UNITED STATES OF AMERICA
NUCLEAR REGULATORY COMMISSION

(Comanche Peak Steam Electric Station
Station, Units 1 and 2)

CASE'S ANSWER TO APPLICANTS' STATEMENT OF MATERIAL FACTS
AS TO WHICH THERE IS NO GENUINE ISSUE REGARDING CASE'S ALLEGATIONS
REGARDING U-BOLTS ACTING AS TWO-WAY RESTRAINTS

AFFIDAVIT OF CASE WITNESS MARK WALSH

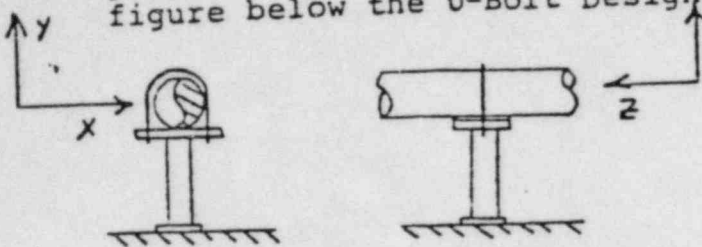
Once an initial run is made, for those supports which have a U-Bolt but only one design load the piping movements in the perpendicular direction must be reviewed. For example in the figure below the U-Bolt Design load was F_y . The piping is essentially free to move in the Z direction. However, the U-Bolt offers resistance in the X Direction.

It is the X movements which must be reviewed. Only the thermal movements need be checked, the reasoning being that the existence of the lateral stiffness of the U-Bolt is an aid in the seismic analysis, improving on the rigidity of the overall system in a seismic event. It is the thermal condition which is in question since the lateral stiffness jeopardizes the flexibility that may be needed to reduce thermal stresses and equipment nozzle loadings. If the lateral thermal movement is not greater than 1/16 inch then it will be deemed that a problem does not exist. For those cases where the 1/16 inch criteria is violated further analysis is required in step III.

PAGE 66 OF 364

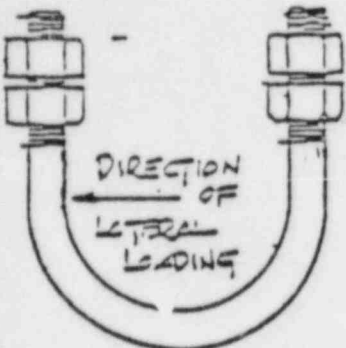
Other examples where the U-bolts, when modelled as two-way restraints, exceed allowables (based on Tables 2, 3, and 4 of Applicants' attachment and PSE Guidelines, Section XII, page 66 of 364, see attached copy) are:
